Work Order ID 160312***160312***

Item Name: AS350/AS355 Quick Release Heli-Utility-Basket™, Short, Heavy Duty Lid

DART SERVICE INSTRUCTION

**TO AMEND INSTALLATION INSTRUCTIONS D350-607-3 Rev.D,
INSTALLATION INSTRUCTIONS D350-607-4 Rev. C AND
INSTRUCTIONS FOR CONTINUED AIRWORTHINESS ICA-D350-607 REV. 6**

FIGURE 1: INSTALLATION OF D4775-041 FWD STRUT

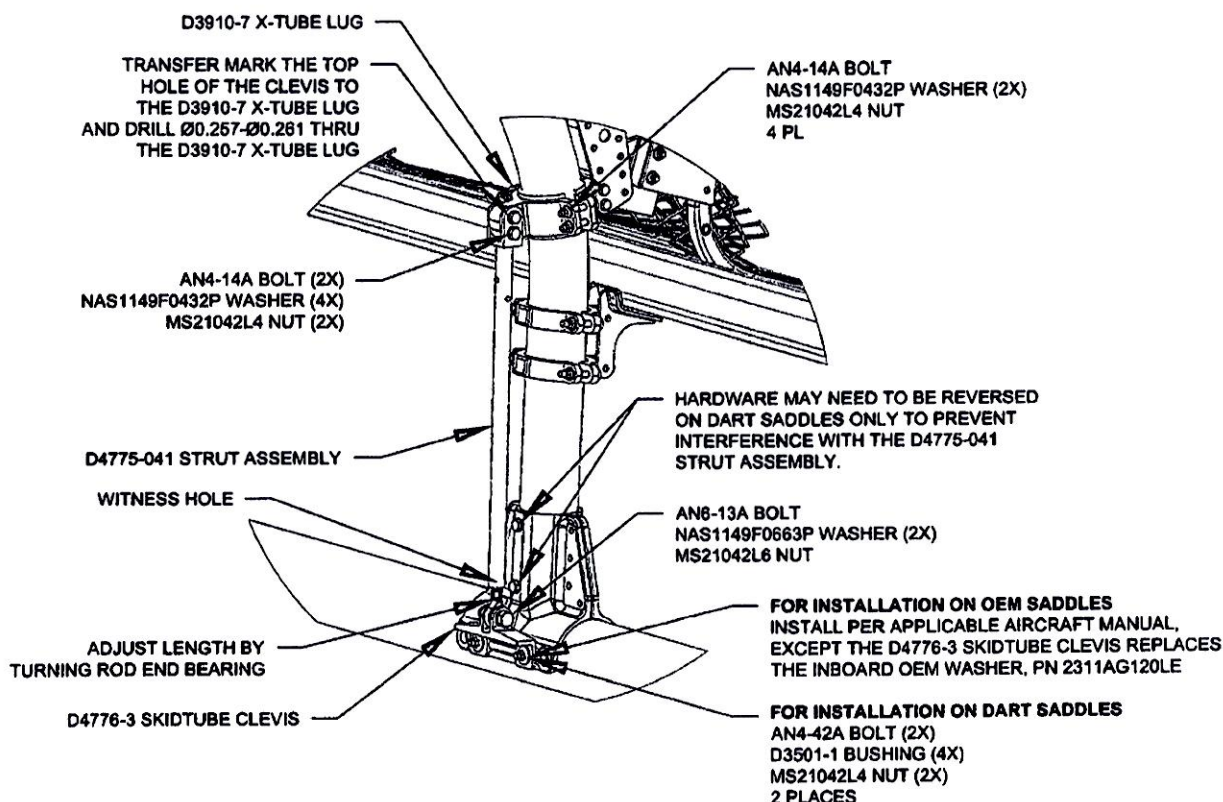
3.1 Substitute the Forward Lower D3910-5 X-Tube Lug with the D3910-7 X-Tube Lug as shown in Figure 1.

3.2 Install the forward D4775-041 Strut Assembly. Transfer mark from the upper hole on the clevis of the D4775-041 Strut Assembly to the D3910-7 X-tube Lug and drill thru the lug $\varnothing 0.257$ - $\varnothing 0.261$ as shown in Figure 1. Touch up chemical conversion coating per MIL-DTL-5541. Check the witness holes located at the bottom end of the D4775-041 Strut Assemblies to ensure that the thread from the rod end extends past the witness hole.
Torque MS21042L4/-4 nuts to 50-70 in-lbs (5.7-7.9 N-m). Torque MS21042L6/-6 nuts to 160-190 in-lbs (18.1-21.5 N-m).
